Response to Comments Report

Tentative Order No. R9-2023-0004

Waste Discharge Requirements for the University of California San Diego,
Scripps Institution of Oceanography, Discharge to the Pacific Ocean

March 8, 2023

Figure 1: From page 3 of Craig Carlisle’s comment letter, dated February 6, 2023

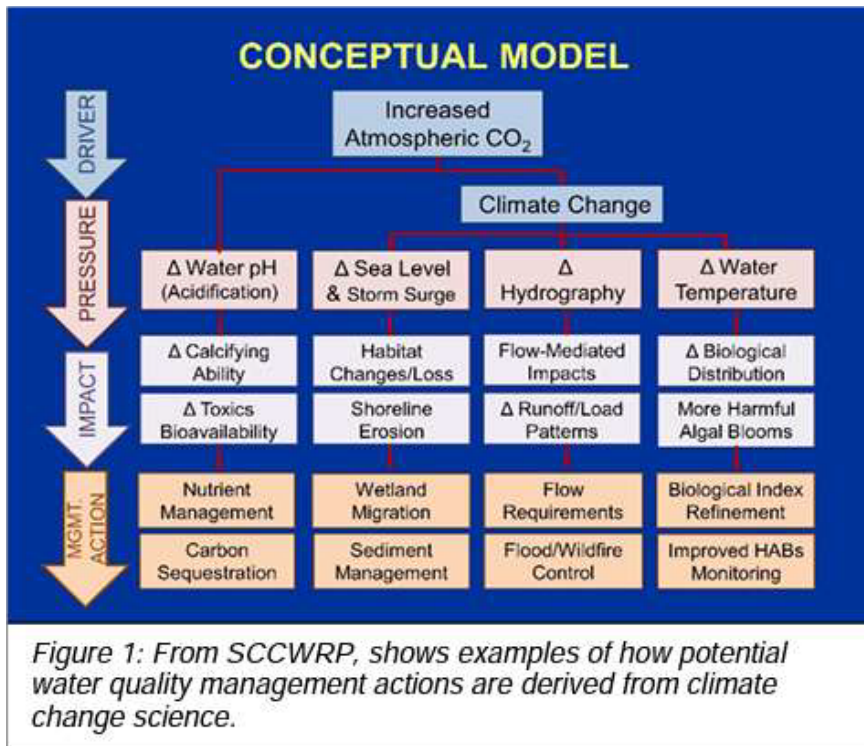
The discharge of wastewater by Scripps Institution of Oceanography is exacerbating the effects of climate change by increasing the erosion of valuable beach sand. Over 30,000 cubic feet of sand are estimated to be removed from this popular beach every year by the discharge. The San Diego Water Board’s Conceptual Model in Resolution R9-2018-0051 *Addressing Threats to Beneficial Uses from Climate Change* identifies shoreline erosion as an impact from climate change.

The Resolution also has “Ensure low-gradient beaches remain accessible for recreational uses” listed as “Top Goals Related to Climate Change” in Table 1 along with “Flow Requirements” as a “Management Action.” Unfortunately, Resolutions do nothing until actions are actually taken and this is an excellent opportunity to clearly demonstrate commitment to the concepts in the Resolution by eliminating or at least reducing the discharge’s negative impacts.

The San Diego Water Board agrees that San Diego Water Board Resolution No. R9-2018-0051, *Addressing Threats to Beneficial Uses from Climate Change* (San Diego Water Board Climate Change Resolution) identifies shoreline erosion as an impact of climate change, and Table 1 of the San Diego Water Board Climate Change Resolution lists “ensuring low-gradient beaches remain accessible for recreational users.” Discharges from the Facility’s outfalls, however, do not render the beach inaccessible for water contact or non-contact recreational uses. In addition, a significant amount of the sand displaced by the discharges is replenished at high tide. Further, the overarching goal of the San Diego Water Board Climate Change Resolution is to address issues caused by climate change, such as how discharges from facilities may cause ocean acidification; or addressing how factors related to climate change such as sea level rise or changing rainfall patterns may affect treatment facilities or the quality of discharges. This discharge is different because it comprises of treated seawater and/or stormwater to a beach and is not a result of climate change. Nevertheless, the Tentative Order is consistent with the goals of the San Diego Water Board Climate Change Resolution and State Water Board Resolution No. 2017-0012, *Comprehensive Response to Climate Change* because it requires the Discharger to develop and submit a climate change action plan (CCAP) within 3 years of the effective date. The CCAP requires the Discharger to identify steps being taken to address climate change related impacts on the Facility (includes intake structures, storage and conveyance facilities, treatment facilities, and outfalls). The CCAP will also include steps taken or planned to address impacts such as sea level rise, volatile rain period impacts (both dry and wet weather); impacts on intake water quality; impacts on operations of treatment systems and on quality of the discharge and identify need to adjust permit conditions.
